SERVICE BULLETIN

492

TIGO-541-E1A Exhaust System Modification.

PA-31P Pressurized Navajo

Figure 1.

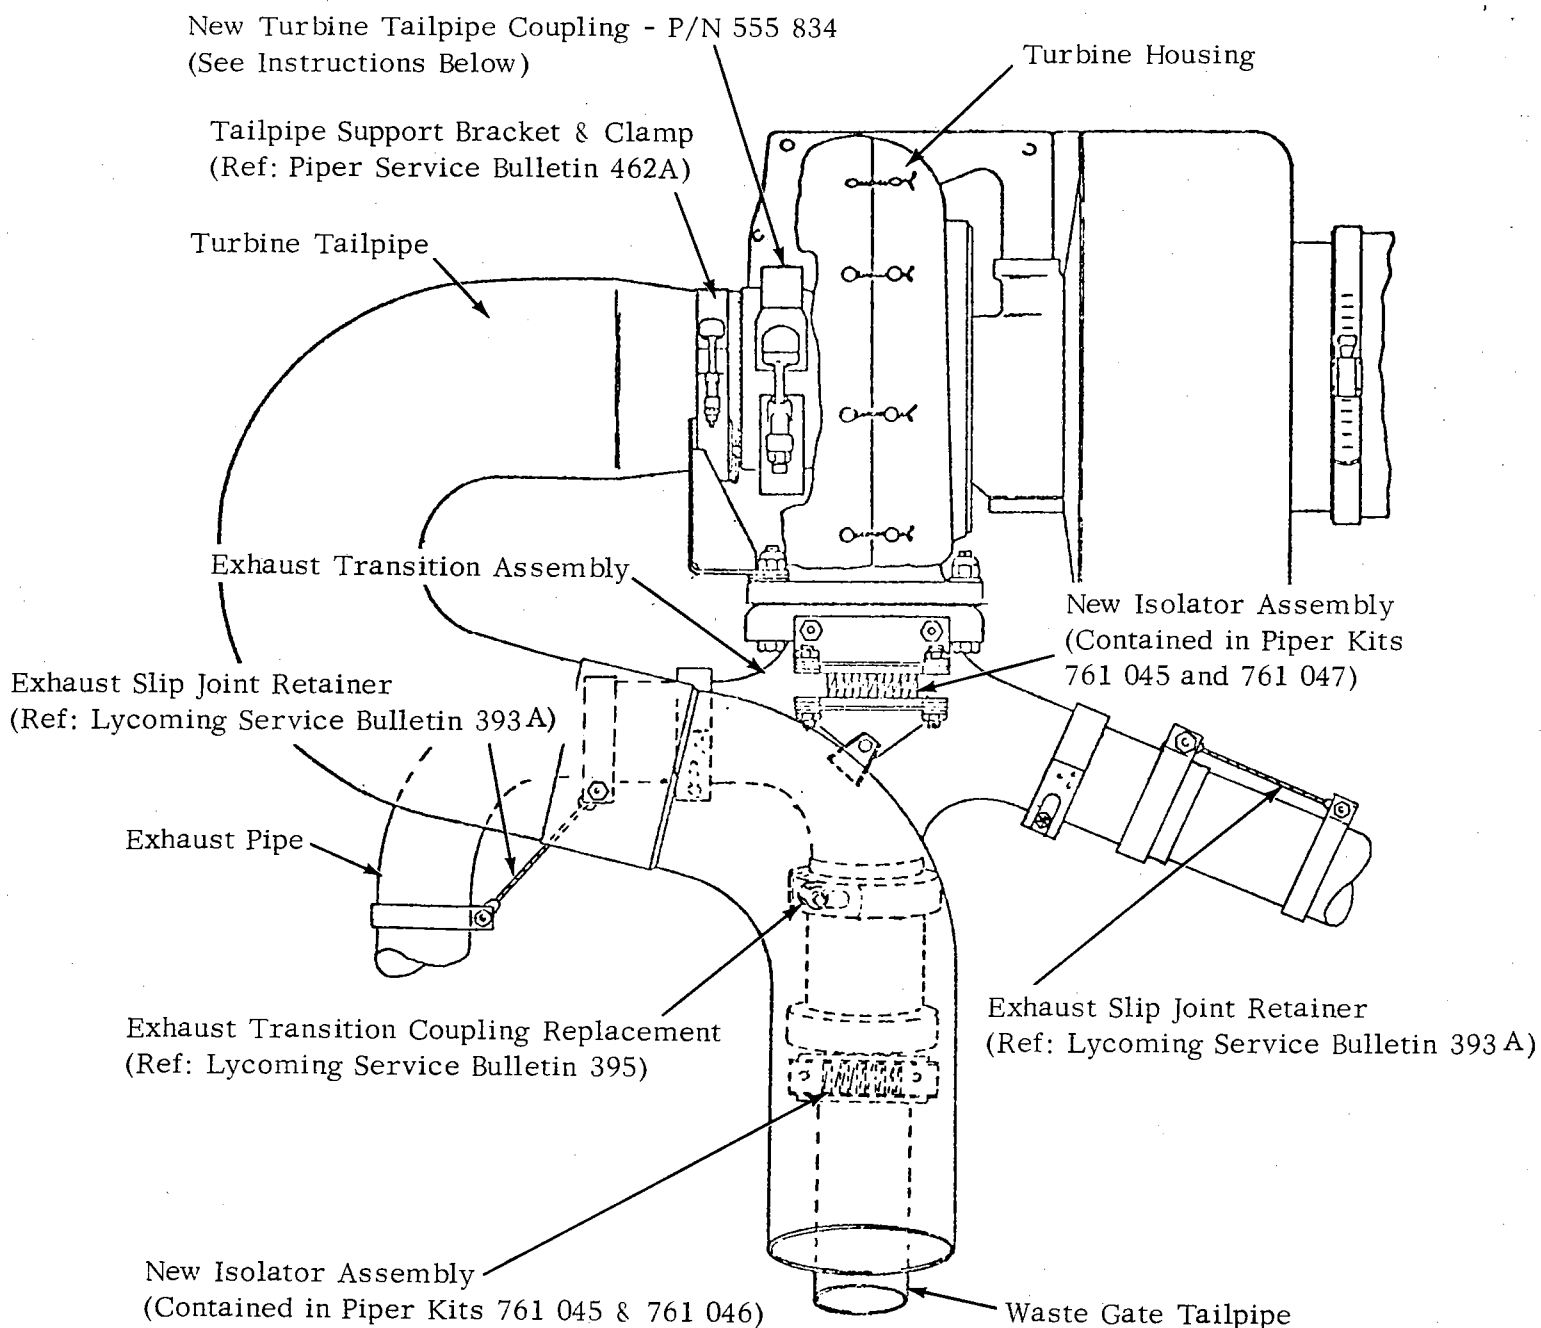
1. Refer to attached sketch/instruction sheet (figure 1) which illustrates the exhaust system components to be installed or replaced (references: Piper Service Bulletin No. 462A, AVCO Lycoming Service Bulletin Nos. 393A and 395 attached, and Material Required, below).
 - a. Install new Turbine Tailpipe Coupling, Piper Part Number 555 834 per sketch/instruction sheet Instructions.
2. Reference attached AVCO Lycoming Service Instructions No. 1320 Exhaust Manifold Components Tightening Procedures.
3. Inspect complete exhaust system for cracks, exhaust leakage evidence, looseness at joints, etc; correct as required.
4. Make appropriate log book entry indicating compliance with this service bulletin; be sure to record compliance with other service releases referred to in this release.

INSTRUCTIONS - Turbine Tailpipe Coupling Replacement

1. Remove engine cowling from both engines to gain access to the turbine tailpipe couplings.
2. Remove existing couplings and install new couplings P/N 555 834 as follows:
 - a. Install coupling over end of tailpipe flange, spreading clamp a minimum amount.
 - b. Fit tailpipe flange to turbine flange, making certain flange faces are butted together with no gap.
 - c. Position tailpipe for clearance with exhaust pipe. Slide coupling over flanges and tighten. Torque to 45-55 inch pounds.
3. Reinstall engine cowling and make proper logbook entry of coupling replacement.

Figure 1. Exhaust Adapter Pipe Showing Areas Requiring Inspection

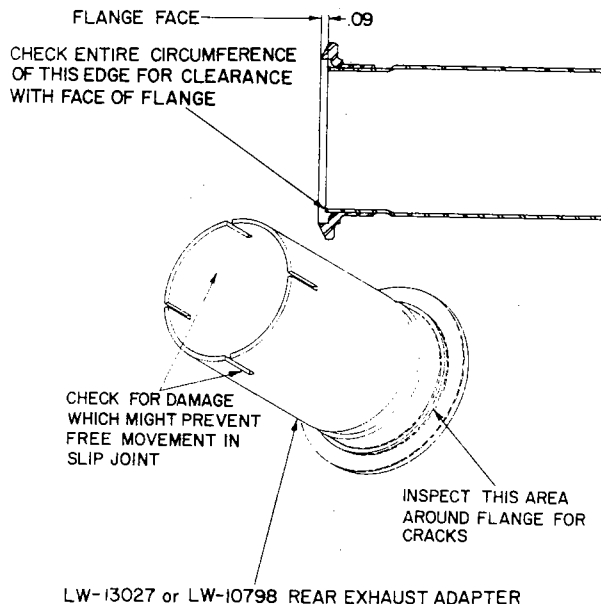
1. Remove spring tensioned rod and clamps or u-bolt clamps as may be the case. These parts are not reused.
2. Inspect exhaust adapter pipes for cracks around flange fillet and slits. (Pipes with or without slits may be reused.) Pay particular attention to condition of slip joint, noting any damage which may prevent free movement of the joint. In addition,

check the end of the adapter pipe inside the flange mouth; it must be .090 inch below the surface of the flange face. Use a hand grinder if necessary to obtain this clearance. (See figure 1.)

Figure 2. Exhaust Manifold Coupling Inspection Requirement

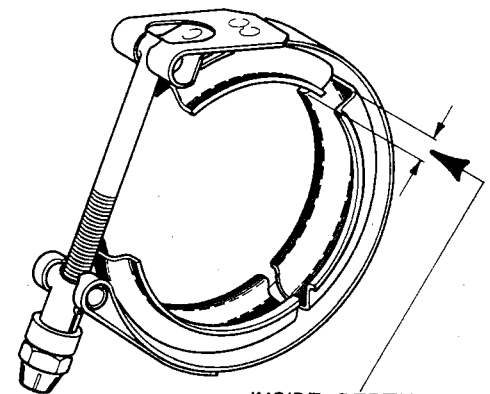
3. Reassemble exhaust adapter pipes to transition assembly using new 78083 gaskets. Check coupling part number. MVT69183-200 Avco Lycoming P/N LW-12093-5 is the number of the correct coupling to be used. Inspect the 3 v-band sections of each coupling with a depth micrometer as shown in figure 2. Any dimension obtained under .230 inch renders the coupling unfit for further service.

Figure 3. Area of Transition Assembly Showing Cable Assembly

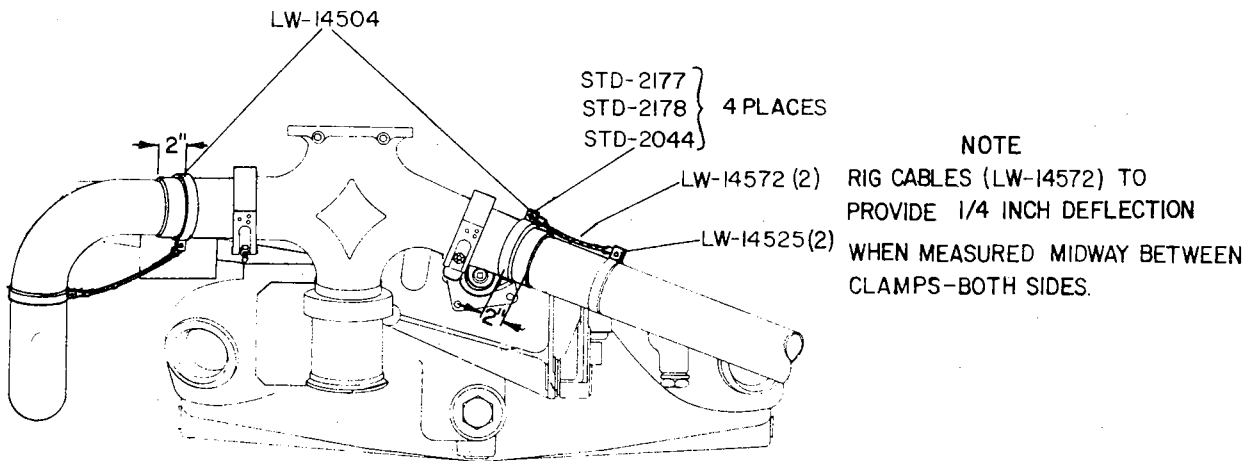
6. Assemble clamps LW-14504 on adapter pipes approximately 2 inches from slip joint and LW-14525 clamps on left and right exhaust pipes. Connect cable assemblies LW-14572 to clamps with attaching parts STD-2177 bolt, STD-2178 washer and STD-2044 nuts. Attach these cables, leaving enough slack to provide 1/4 inch deflection of the cables after assembly. (See figure 3.) Tighten nuts to 60 ± 10 inch/lbs.

Figure 1. Diagram of Rear Portion of Engine Showing Location of Coupling to Attach Transition Assembly and Exhaust Bypass Valve

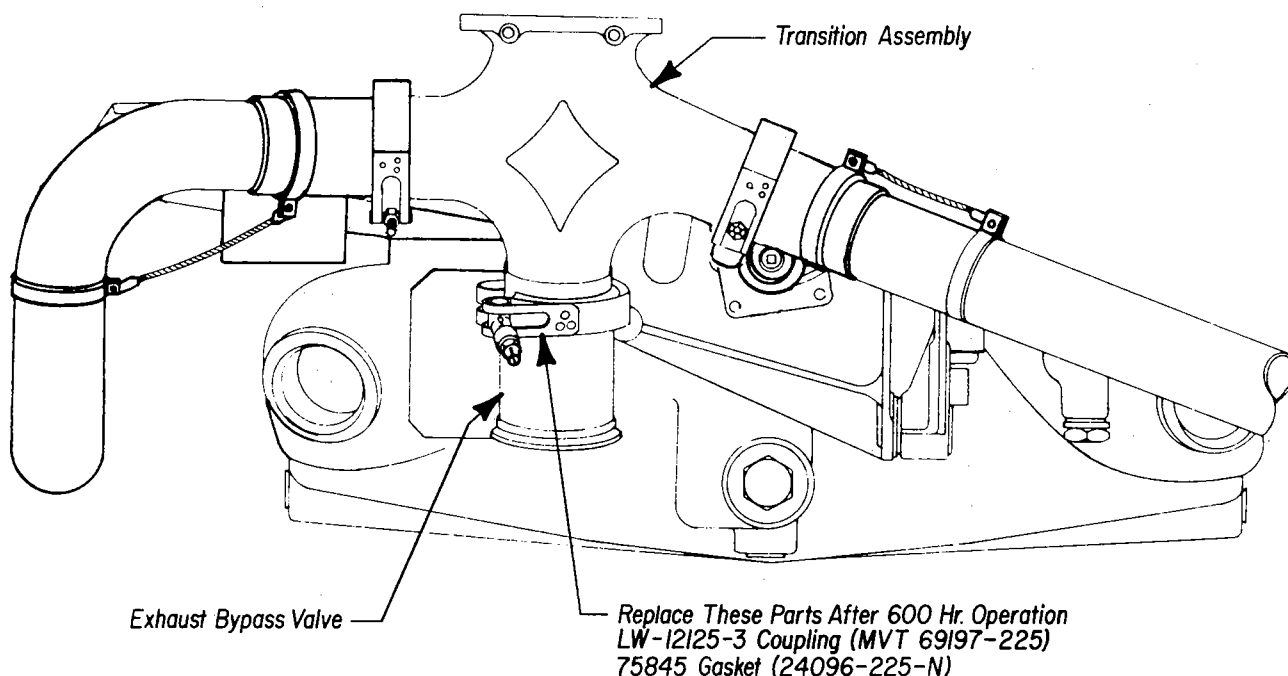
It has been determined that over a long period of time continuous use of the Marmon clamp LW-12125-3 (MVT69197-225) possibly can result in failure from erosion and deterioration, causing severe loss of engine power because of separation from the controlling waste gate. Replacement of the clamp and gasket is accomplished as follows:

1. Loosen the nut that attaches the Marmon clamp located between the transition assembly and the exhaust bypass valve. See figure 1. Remove the clamp and gasket.

Figure 2. Diagram of Section Thru Transition and Exhaust Bypass Valve Showing Details of Clamp and Gasket Assembly

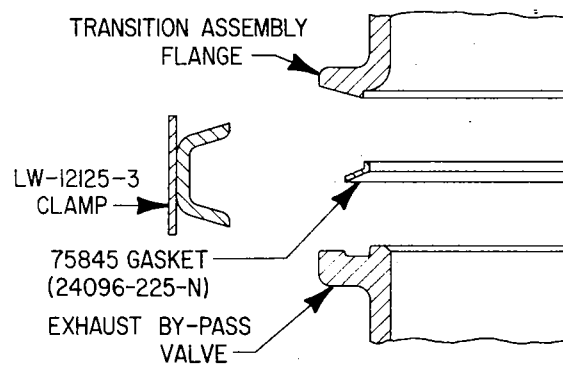
4. Place the gasket P/N 75845 in its proper position between the two mating flanges. Be sure it is seated firmly. Also be sure it is not upside down; that is, the straight, vertical side must face upward. See figure 2.
